May 31, 2016

Re: FirstLight Hydro Generating Company, Turners Falls Hydroelectric Project (FERC No. 1889) and Northfield Mountain Pumped Storage Project (FERC No. 2485).
Response to Stakeholder Requests for Study Modifications and/or New Studies Based on the Study Report and Meeting Summary

Copyright © 2015 FirstLight Power Resources All rights reserved.

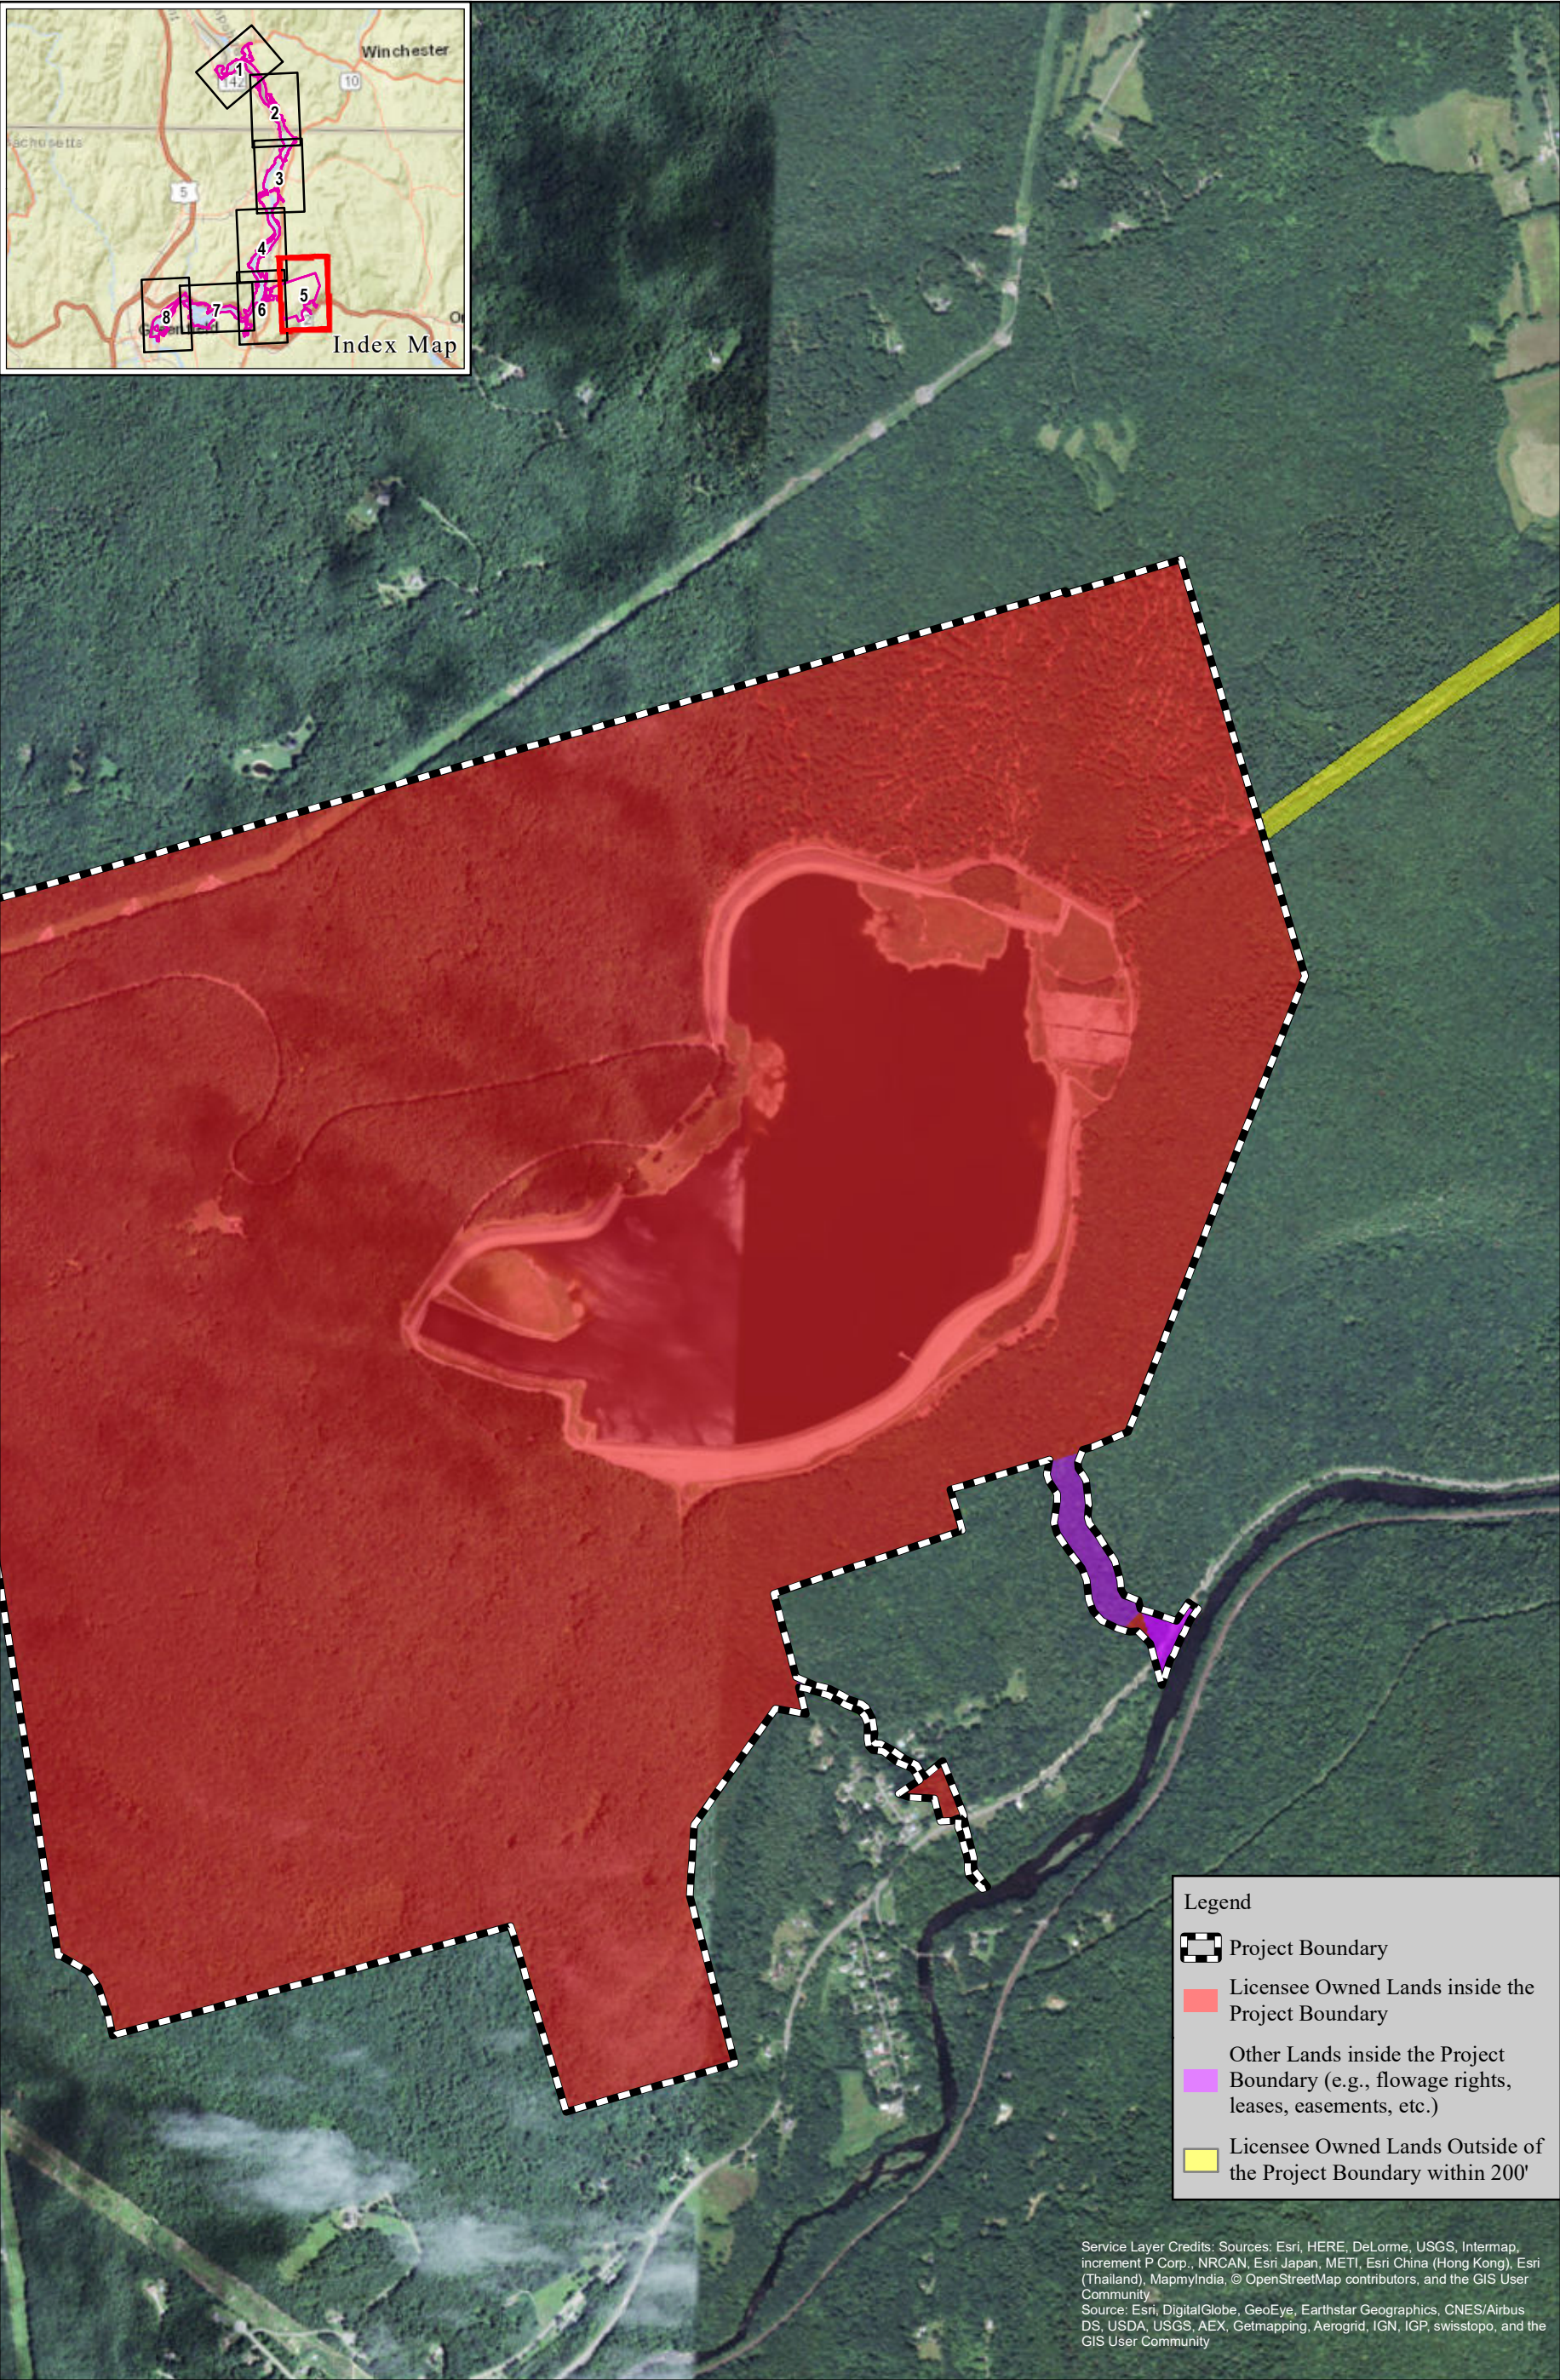
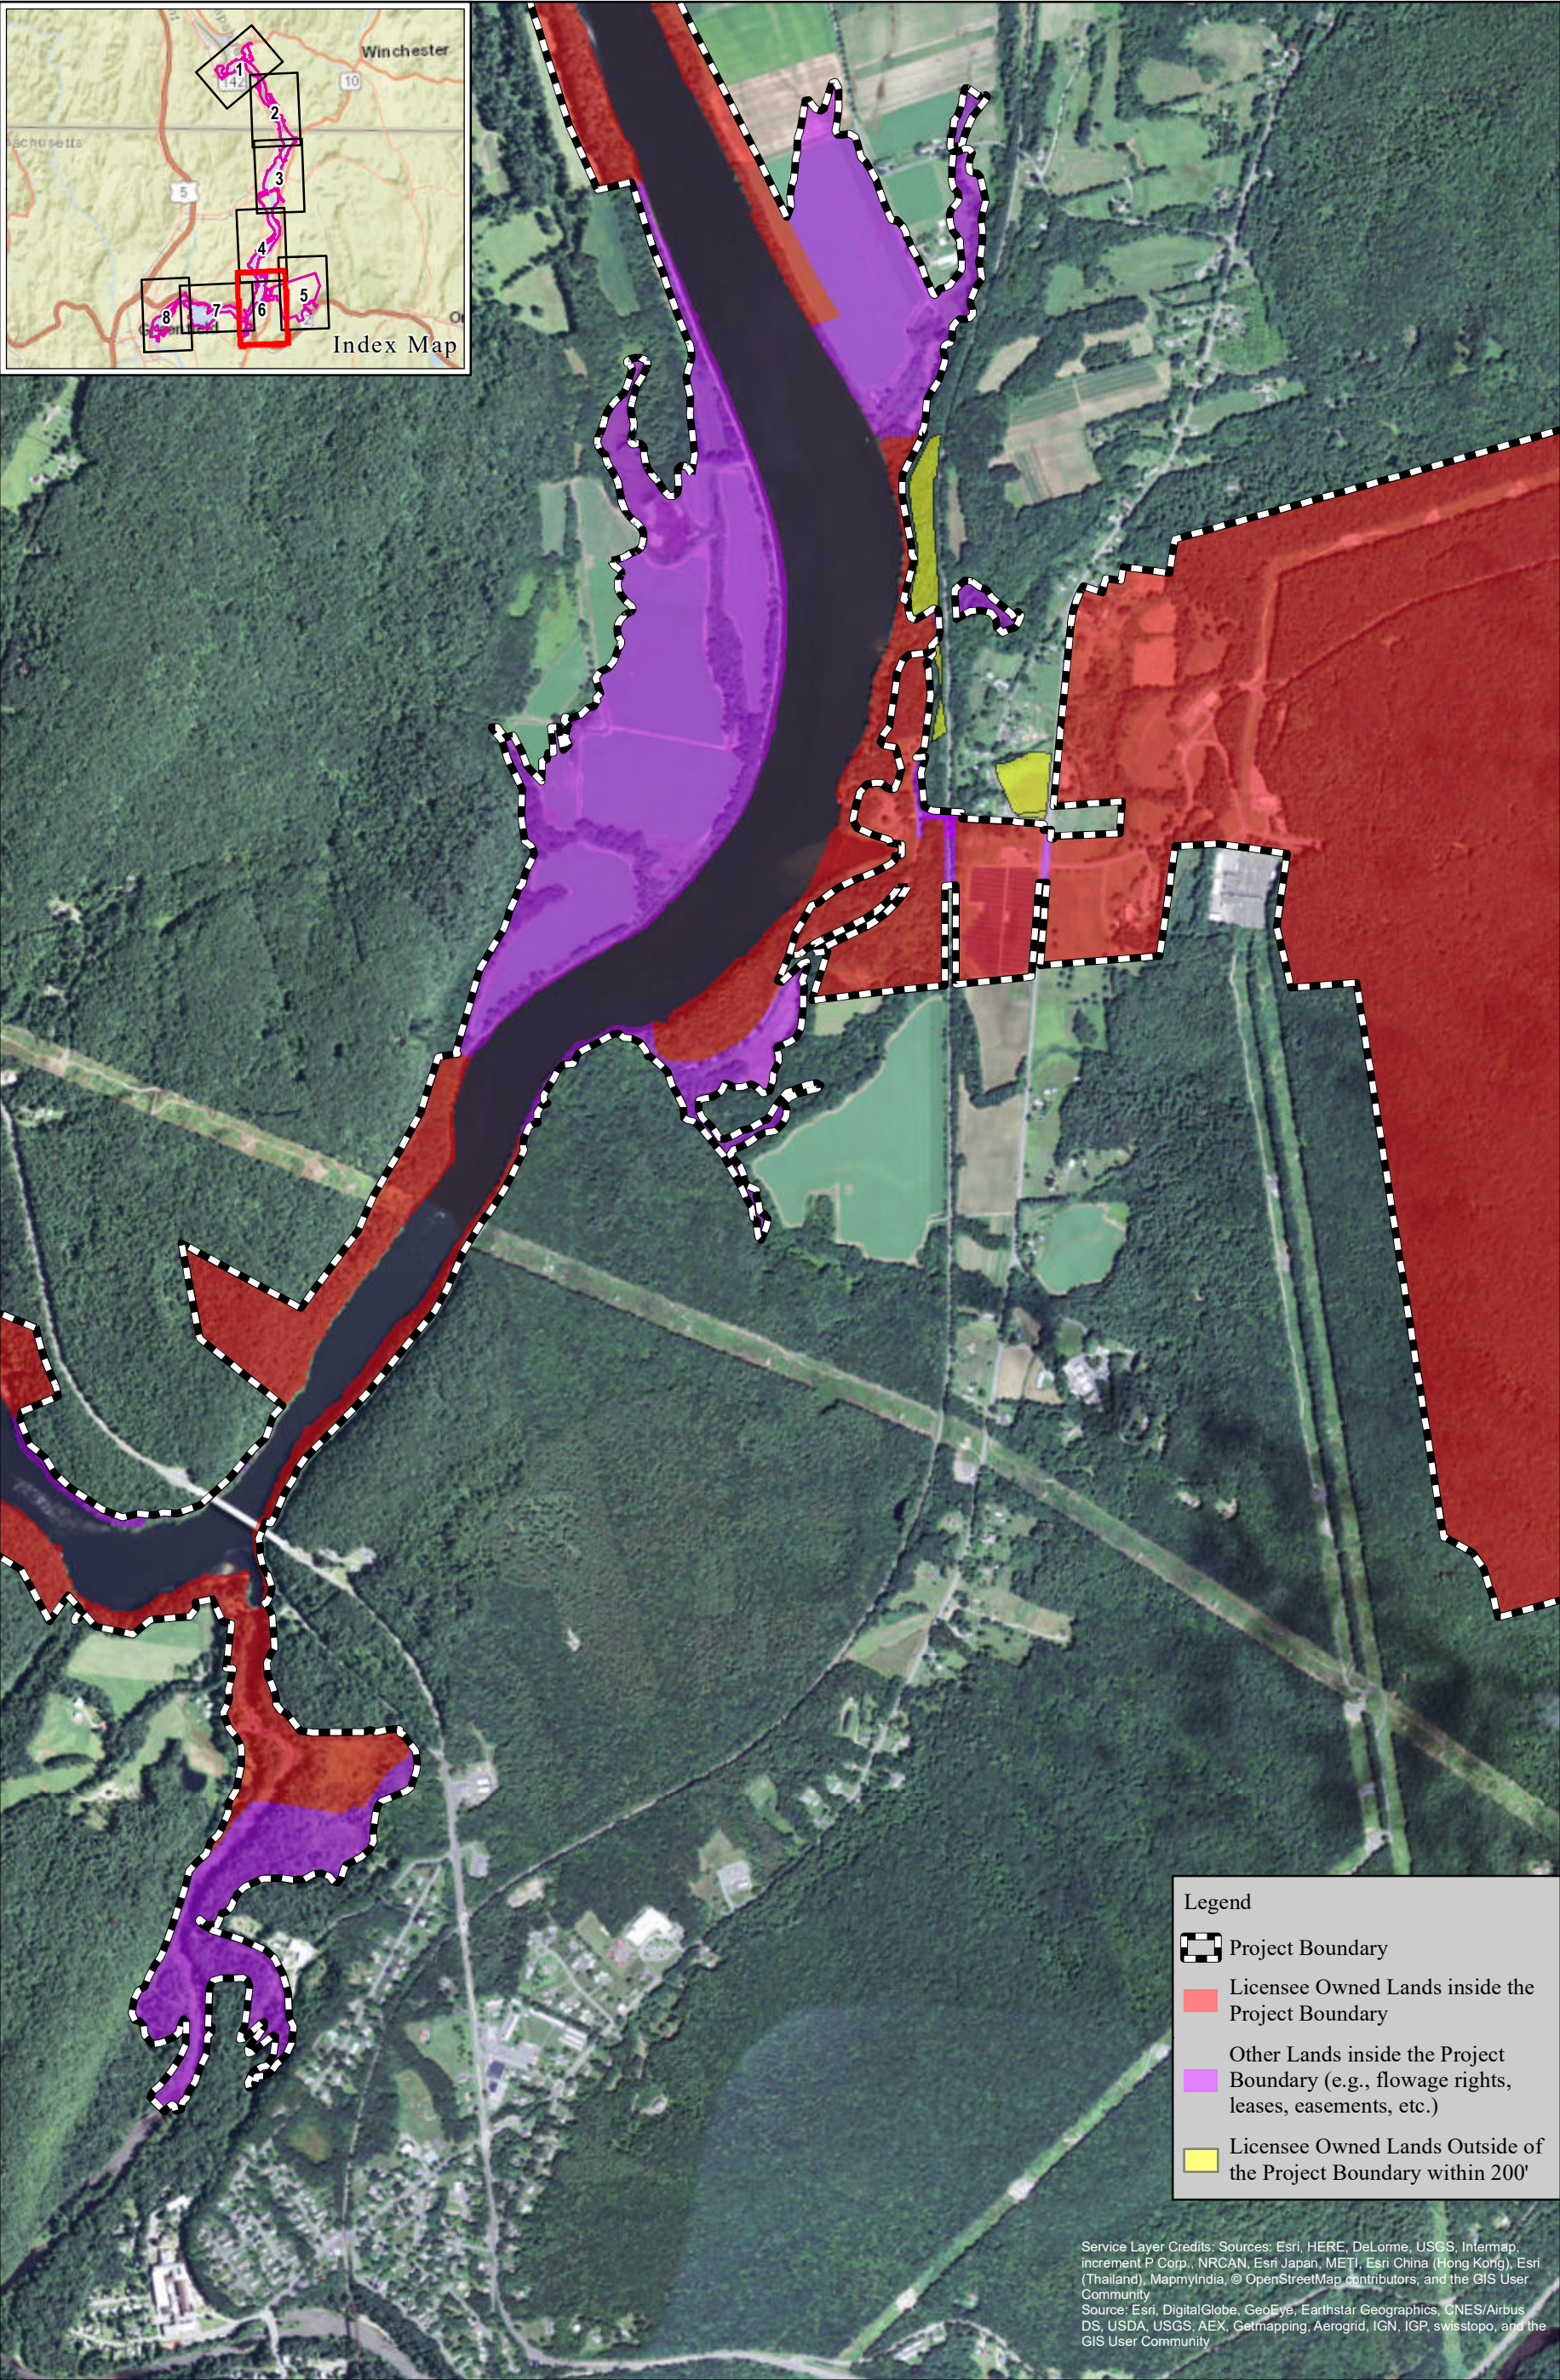
Commenter	Comment	Responses
CRWC-1	The report does not identify ownership and other controls such as FirstLight’s flowage rights within the Project boundaries. FirstLight does not own all of the lands within the project boundaries. FirstLight ownership of lands within 200 feet of the Project boundaries is identified in Figure 4.4-1, but nothing indicates ownership within the boundaries. CRWC requests that FirstLight provide information on land it has ownership or any other control over, and the land use associated with those lands, in an addendum to Study 3.6.5.	FL has updated the maps that comprise Figure 4.4-1 in the 3.6.5 study report to show FL land ownership within the project boundary. See Study 3.6.5 Attachment A , Figure 4.4-1. The lands owned by FL shown are fee-ownership. The figures also show other lands within the Project boundary (e.g., flowage rights, easements, leases, etc.). The land uses associated with all lands within the Project boundary are provided in the 3.6.5 study report. An addendum to the 3.6.5 study report is not necessary.
